Response RAI-NF-12

RAI-NF-13

Figure RAI-NF-12.1: MOP Radionuclide Dose Contributions Using Base Case Modeling Assumptions (Annular Inventories)

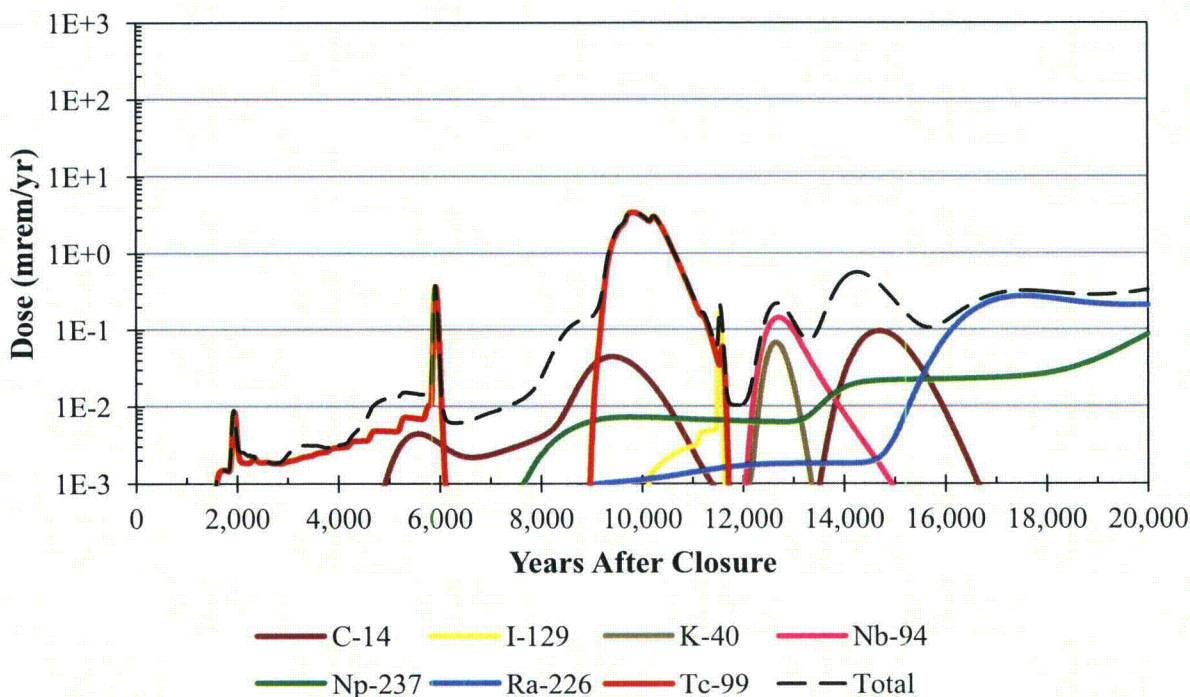
For further insight, and to address more quantitatively this RAI the GoldSim model was used in deterministic mode to develop a set of additional figures showing the radionuclide-specific dose contributions from the assumed annular inventories. These figures show the peak radionuclide doses, regardless of sector. Figure RAI-NF-12.1 shows the radionuclide contributions to the MOP dose from only the annular inventories, using Base Case (Case A) modeling assumptions.

The peak dose in Figure RAI-NF-12.1, near 9,800 years after final facility closure, occurs due to the oxidation of the annular grout for the Type I tanks with intact liners (Tanks 9, 10, and 11). Note that in the GoldSim model, this transition occurs around 8,700 years. Prior to this transition, less than 1 % of the Tc-99 within the annulus inventories of Tanks 9, 10, and 11 is released. The combined annulus inventory doses from these three waste tanks peaks at approximately 3.5 mrem/yr.

In comparison, the primary and secondary waste tank liners are assumed initially failed in Tank 12, allowing more groundwater to flow through the waste tank such that the annular grout transitions earlier (around 6,000 years after final facility closure). The Tc-99 in the Tank 12 annulus inventory provides a peak dose of approximately 0.4 mrem/yr.

Figure RAI-NF-12.2: MOP Radionuclide Dose Contributions Using Pessimistic Modeling Assumptions (Annular Inventories)

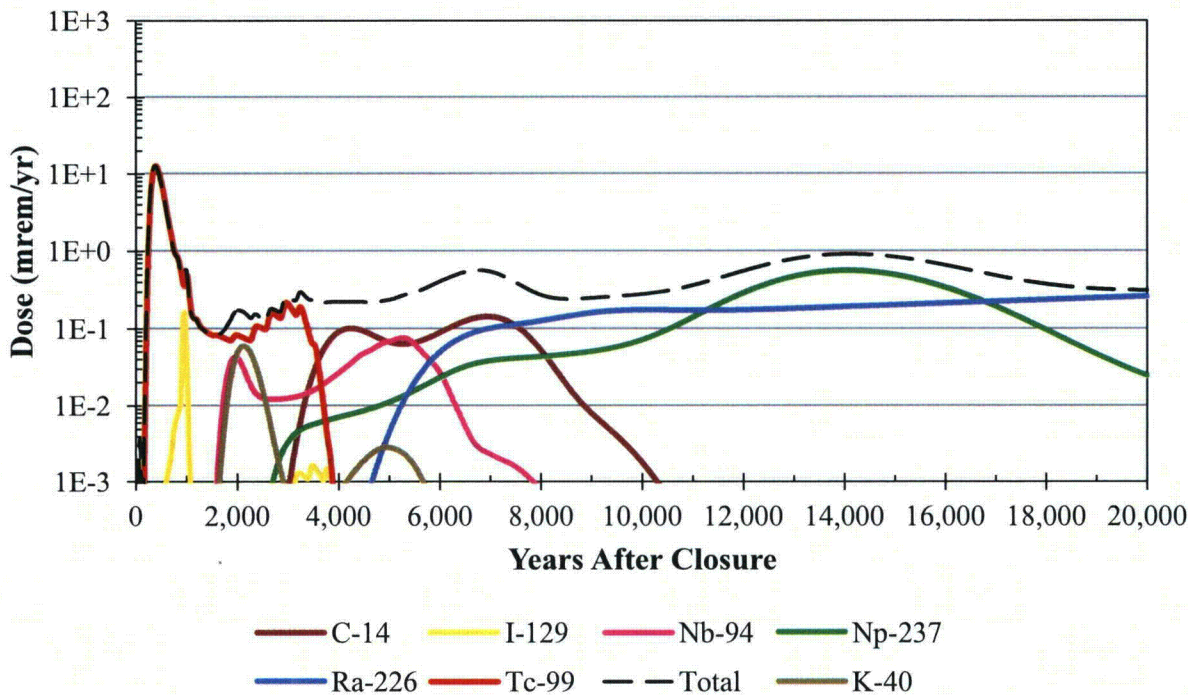
Figure RAI-NF-12.2 shows the radionuclide contributions to the MOP dose, regardless of sector, from only the annular inventories, using pessimistic modeling assumptions. These assumptions are defined in the response to RAI-NF-8 (for the model identified as “Flow Run 65, No Holdup”). This pessimistic model releases the majority of the contaminants at the start of the simulation and includes assumptions that accelerate flow.

In this pessimistic modeling case, 50 % of the Tc-99 inventories associated with the annular contributions are released within the first 500 years and more than 99 % are released in the first 3,000 years. In this extremely pessimistic modeling scenario, the total dose from the annular contributions within all the HTF waste tank annulus inventories peaks at approximately 13 mrem/yr (around 400 years after final facility closure). This compares to the Base Case modeling approach, which peaked at less than 4 mrem/yr (around 9,800 years after final facility closure). These results indicate that earlier release of the annulus inventories is not likely to alter the risk significance.

Figure 2. Illustration of the as-modeled sand pad waste and fast pathway in Tanks 14H and 16H

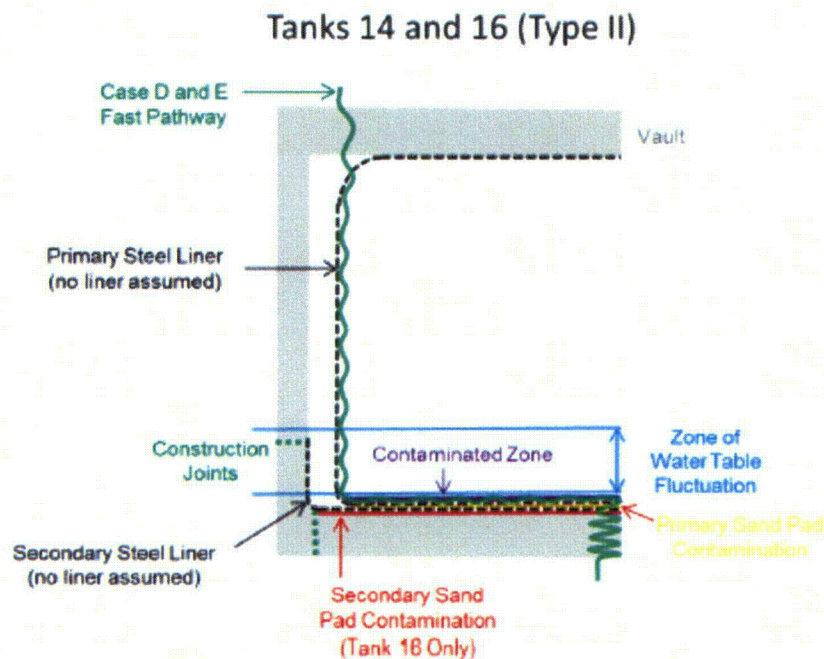
In Tanks 14H and 16H (Type II), it is not clear to what extent the preferential pathway interacts with the waste located in the primary and secondary sand pads.

It appears that a potentially significant fraction of the highly radioactive radionuclide inventory is diffusing into the basemat and/or contaminated zone prior to release. Diffusion of radionuclides out of the primary and secondary sand pads is facilitated in the model by a high diffusion coefficient, large concentration gradient, small diffusion length, assumption of no steel liners, and a delay in the flow through the fast pathway due to closure cap. Although the steel liners are not assumed to not be intact for Tanks 14H and 16H due to the large number of leak sites, the steel liner could still act as a partial barrier to diffusion. Also, the delay in flow through the preferential pathway, due to the assumption of flow being limited to infiltration through the closure cap, may overestimate the amount of time radionuclides can diffuse out of the sand pads if groundwater in-leakage were to occur.

DOE should discuss the extent to which the preferential flow path affects the waste located in the sand pads and its risk significance. This should include the fraction of the inventory of the short-lived radionuclides (e.g., cesium-137 and strontium-90) that decay prior to significant flow occurring in the fast flow path. DOE should also provide discussion regarding the fraction of the highly radioactive radionuclides (e.g., technetium, plutonium, and neptunium) that diffuse out of the sand pads and into the grout or basemat.

Waste inventories assumed within the sand pads are not expected to contribute significantly to risk despite assuming what is believed to be bounding values relative to the assigned inventories within these sand pads. When modeling the annulus and sand pads, no special effort was made to prevent material in these regions from migrating into the contamination zone within the waste tanks (i.e., adding to the in-tank inventories) because this modeling assumption is expected to maximize the overall HTF peak doses.

As discussed in the response to RAI-NF-8, diffusion of contaminants from the annulus and sand pads inventories into annular or waste tank grout is an unintended consequence of a modeling simplification. As discussed in the response to RAI-NF-8, the simplified approach taken facilitates modeling of solubility controls that are appropriate under most conditions.

Figure RAI-NF-13.1: MOP Radionuclide Dose Contributions (from the Sand Pads) Using Base Case Modeling Assumptions

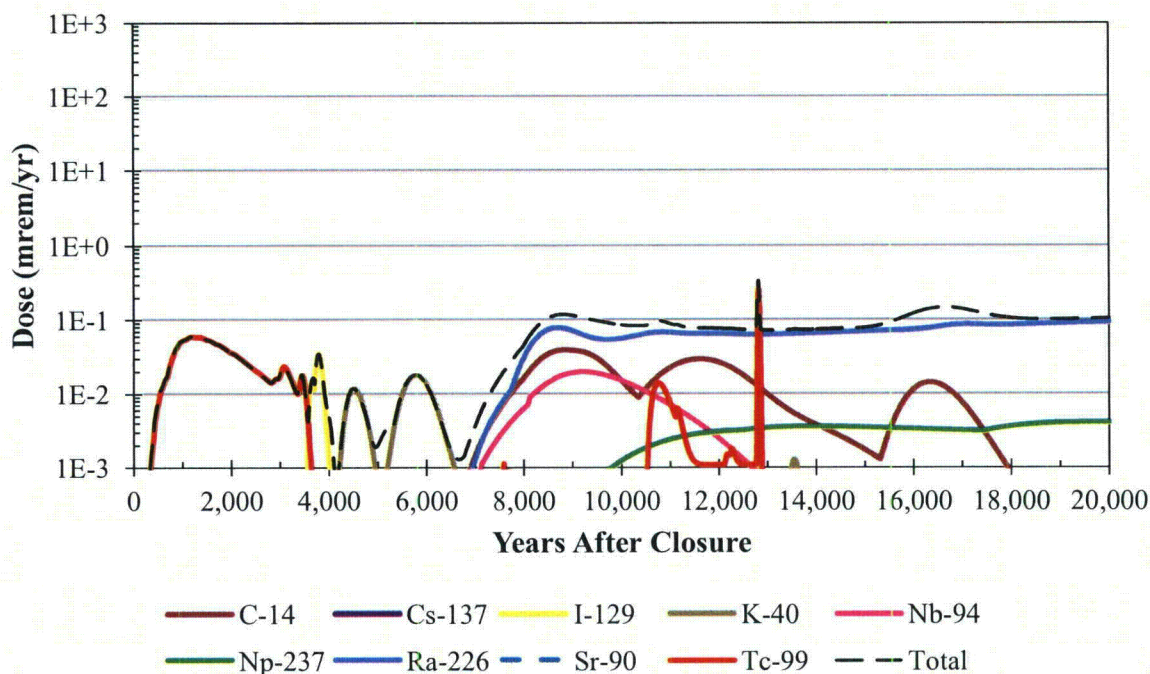
For greater insight, the GoldSim model was used in deterministic mode to develop a set of additional figures showing the radionuclide-specific dose contributions from the assumed sand pads inventories. These figures show the peak radionuclide doses, regardless of sector. Figure RAI-NF-13.1 shows the radionuclide contributions to the MOP dose from only the sand pads inventories (i.e., Tanks 13-16 sand pads) using Base Case (Case A) modeling assumptions.

The peak dose in this figure occurs once the primary liner for Tank 13 fails (around 12,700 years after closure). As an artifact of the modeling approach, more than half (approximately 55 %) of the Tc-99 artificially migrates (via diffusion) from the sand pads, through the primary and secondary liners, and into the contamination zone and remains there until liner failure.

Alternatively, this diffusion effect is minimized for Tanks 14, 15, and 16 because the majority of the available inventory is advectively transported out of the contamination zone (due to assumed liner failure at the start of the simulation). Figure RAI-NF-13.1 shows a low magnitude Tc-99 dose occurring in the first 4,000 years. This dose comes from the sand pads inventories from Tanks 14, 15, and 16, of which 99 % of the Tc-99 is released within the first 4,000 years.

The peak Tc-99 dose from the Tank 13 sand pads is approximately 0.26 mrem/yr; whereas the peak Tc-99 dose from the Tank 16 sand pads is one order of magnitude smaller (0.024 mrem/yr), despite a much earlier release and a Tank 16 Tc-99 sand pads inventory that is approximately one order of magnitude higher than in Tank 13. Therefore, the holdup of Tc-99 that has migrated into the contamination zone is conservative.

Also note that Cs-137 and Sr-90 are included in the legend for Figure RAI-NF-13.1; however, these radionuclides have no dose significance as they decay before they are able to contribute to the peak dose.

Figure RAI-NF-13.2: MOP Radionuclide Dose Contributions (from the Sand Pads) Using Pessimistic Modeling Assumptions

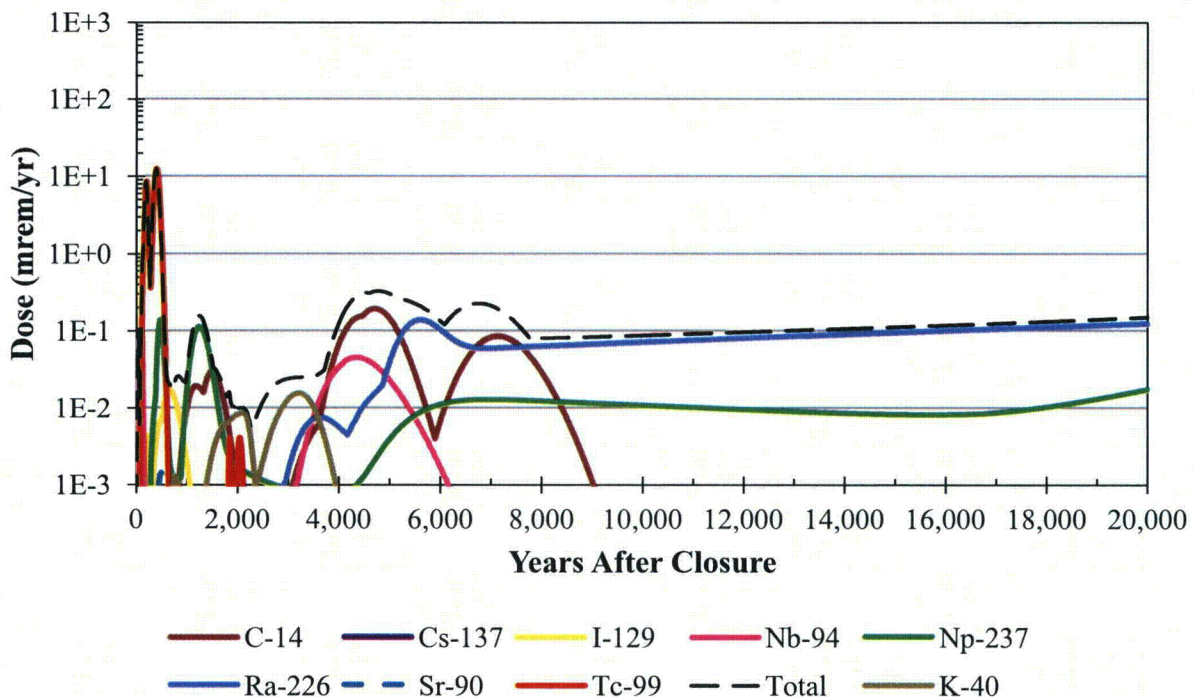
Figure RAI-NF-13.2 shows the radionuclide contributions to the MOP dose, regardless of sector, from only the sand pads inventories, using pessimistic modeling assumptions. These assumptions are defined in the response to RAI-NF-8 (for the model identified as "Flow Run 65, No Holdup"). This pessimistic model releases the majority of the contaminants at the start of the simulation and includes assumptions that accelerate flow.

In this pessimistic modeling case, more than 99 % of the Tc-99 inventories associated with the sand pads are released within the first 300 years. Tank 16 contributes a higher Tc-99 peak dose (approximately 8.2 mrem/yr) than Tank 13 (approximately 0.42 mrem/yr), which is consistent with the higher initial inventory.

Again, note that Cs-137 and Sr-90 are included in the legend for Figure RAI-NF-13.2. A small amount of Sr-90 is visible in the figure (0.0014 mrem/yr at about 500 years after final facility closure). The Cs-137 dose never exceeds 3E-07 mrem/yr. Even under these pessimistic modeling conditions, Cs-137 and Sr-90 significantly decay before these radionuclides can contribute to the MOP peak dose. A review of the inadvertent intruder results confirmed that Cs-137 and Sr-90 also had no significant contribution to the inadvertent intruder peak-dose results. Therefore, Cs-137 and Sr-90 from the sand pads inventories have no dose significance.

Figure RAI-NF-14.1: Horizontal Location of Source Cells for Waste Tanks and Ancillary Structures

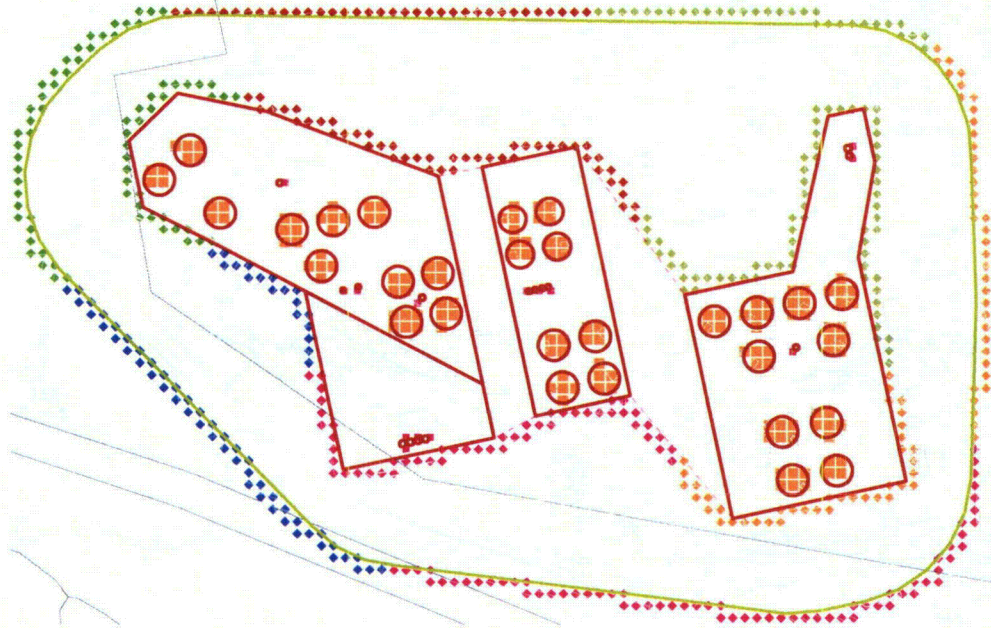
DOE should clarify the location of source loading (elevation of source release relative to the water table) and the number of source cells used to represent the source. DOE should provide an estimate of the range in potential dose based on dilution or concentration of the contaminant flux given source loading selections.

The HTF PA near-field models encompass both unsaturated and saturated conditions depending on the structure being simulated. For near-field model domains extending down to the water table, the aquifer modeling cells are set to the solute flux leaving the model domain (crossing the water table). For near-field model domains that extend into the water table, the aquifer modeling cells are defined to be the solute flux leaving the engineered system (entering surrounding soil) rather than the model domain. Near-field sources that are submerged fully or partially are treated in this manner. That is, near-field models all of the Type I and Type II tanks, and the transfer lines and ancillary structures within the vicinity of the Type I and Type II tanks include a portion of the saturated zone, but the flux leaving the waste tank concrete vault is modeled as aquifer modeling cells.

Aquifer modeling cells for waste tanks are defined in the horizontal plane as those computational cells with centers residing within the physical footprint of the waste tanks. For smaller sources, the nearest cell center is selected. The number of source cells varies between four and six for waste tanks. Vertically, the aquifer modeling cells are placed at the lower of the highest fully saturated cell and the cell coinciding with the basemat elevation. Figures RAI-NF-14.1 and RAI-NF-14.2 show the horizontal and vertical positions, respectively; of the HTF source nodes (note that the vertical height is exaggerated). Among waste tanks, only sources for the fully submerged waste tanks are significantly below the water table. Computational cells at the water table beneath H Area are roughly 20 feet deep and become thinner with depth (e.g., on the order of 7 feet deep in the UTRA-LZ). DOE has not investigated the specific impact of grid resolution in the source zone on solute transport, but has studied general numerical dispersion/dilution within the HTF modeling sectors (see the *Comment Response Matrix for United States Nuclear Regulatory Commission Staff Comments on the Draft Basis for Section 3116 Determination and Associated Performance Assessment for the F-Tank Farm at the Savannah River Site*, SRR-CWDA-2011-00054, RAI-FF-3).

Figure RAI-FF-3.11: Far Field Flow Variability Study Peak Doses

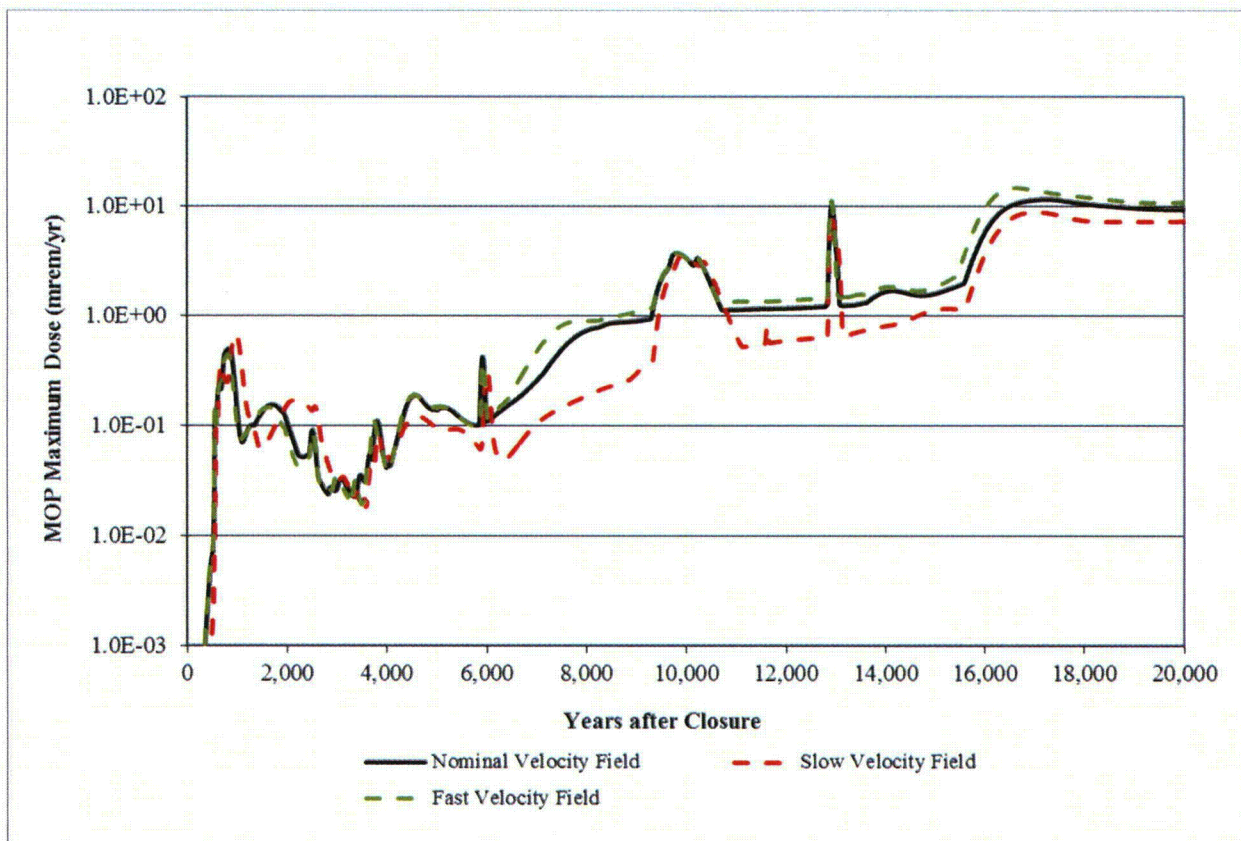
- Clarify the horizontal and vertical extent of hydraulic conductivity adjustments at HTF.
- Provide additional support for the hydraulic conductivities assumed for HTF.
- Evaluate the impact of hydraulic conductivity adjustments on key radionuclide concentrations and dose at the compliance boundaries.

Figure RAI-FF-3.11 depicts peak dose curves (from any sector) for the three runs. Comparing the dose curves presented in Figure RAI-FF-3.11 it can be seen that there is relatively little difference between the three dose curves. In early years, the slow-flow results have the highest peaks of the three runs, mainly reflecting a decrease in Tc-99 dilution, due to lower flow rates. In later years, the lower flow-rate run generates lower doses, reflecting the dose contribution of Ra-226, a radionuclide with a relatively high decay rate, that is moderately to strongly sorbed in the soil. For Ra-226, the influence of the slower flow rates on decay dominates over the influence of decreased dilution. Even when other species control the shape of the peak, such as Tc-99 at 10,000 years, the lower Ra-226 dose contributions lower the peak values. Comparing the nominal flow-rate results with the fast flow-rate results in Figure RAI-FF-3.11 shows that the faster-flow tends to produce slightly lower dose levels at early times and then increases the dose levels later on. This once again reflects the importance of dilution (which increases in the faster-flow runs) on the species controlling the early time doses, and the influence of flow rate on decay of the species controlling the later time doses.

Figure RAI-FF-4.1: Water Table Contour Maps for GSA

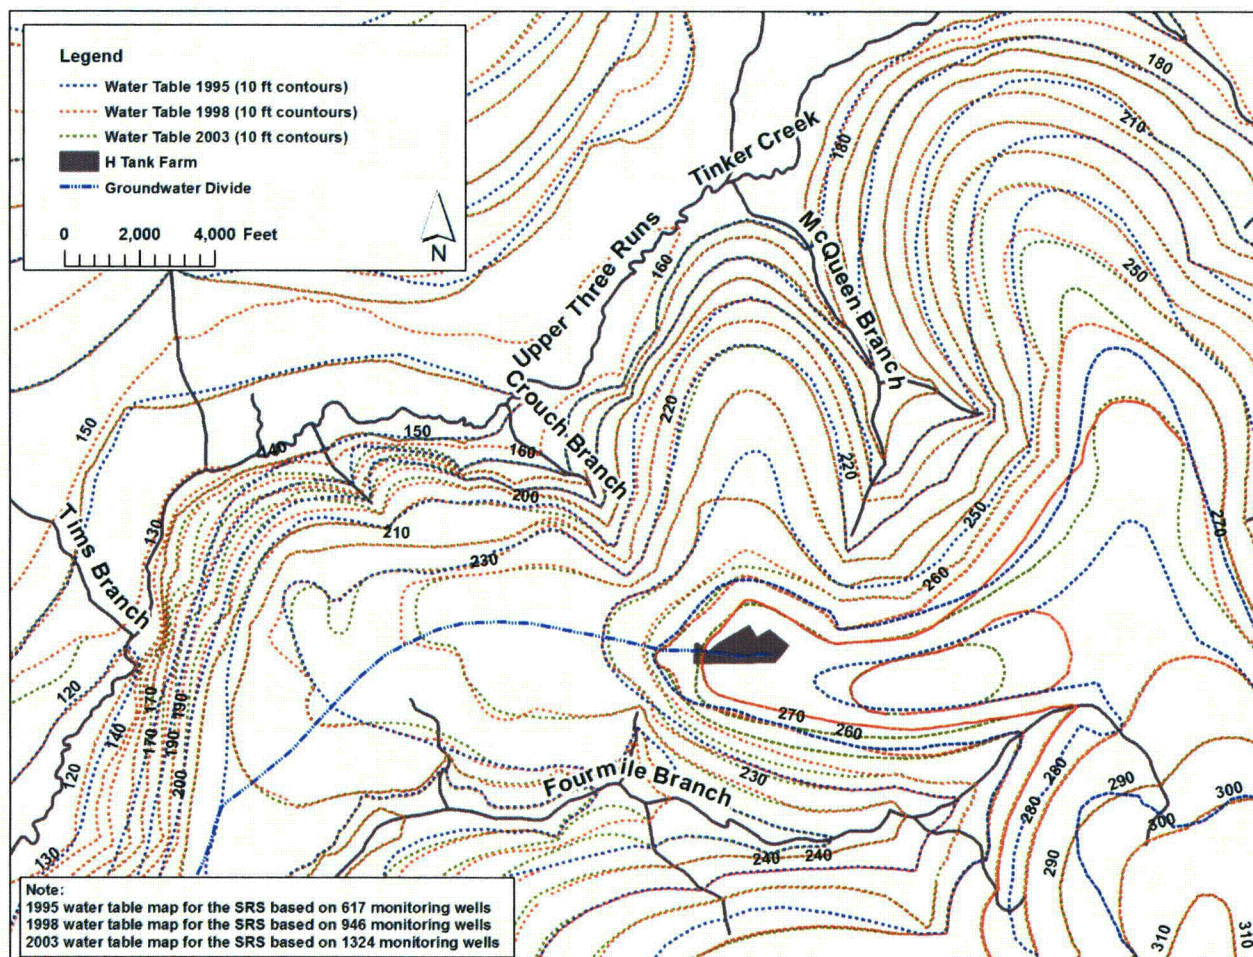
DOE could perform the following activities to evaluate the impact of time-variant recharge and flow at HTF. Note that some of the activities have been partially evaluated in PORTAGE-08-022, Rev. 0. This report can be used as a starting point in addressing this request for additional information but additional detail would be helpful.

A comparison of historic water table data over time is presented in Figure RAI-FF-4.1. Contour surfaces for three years (1995, 1998, and 2003) are overlain for comparison. For reference, the location of HTF and the associated groundwater divide have been denoted. For the HTF, groundwater discharge from the water table aquifer is to Crouch Branch and McQueen Branch, and ultimately to UTR, to the north and to Fourmile Branch to the south. As indicated by the contouring, slight variations exist between localized individual contours, but the overall shape (including groundwater divides), direction of flow, and discharge points remain constant. These contours are consistent with each other, indicating that there has not been a significant change in our understanding of long-term average water table conditions in the GSA since the mid-1990s. In 1995, 617 monitoring wells were used in contour mapping. In 1998, the number of wells increased to 946. Finally in 2003, the number of wells for contouring increased to 1,324. As indicated by this figure, varying the number of wells used to create the maps does not result in significant variation in shape of the overall contour map and the location, orientation and

relative intensity of the groundwater divide within the vicinity of the HTF. Therefore, it is highly unlikely that modest changes in recharge to the water table, such as those experienced over the past two decades, or additional data will result in a significant shift in the groundwater divide that would alter discharge to surface water.
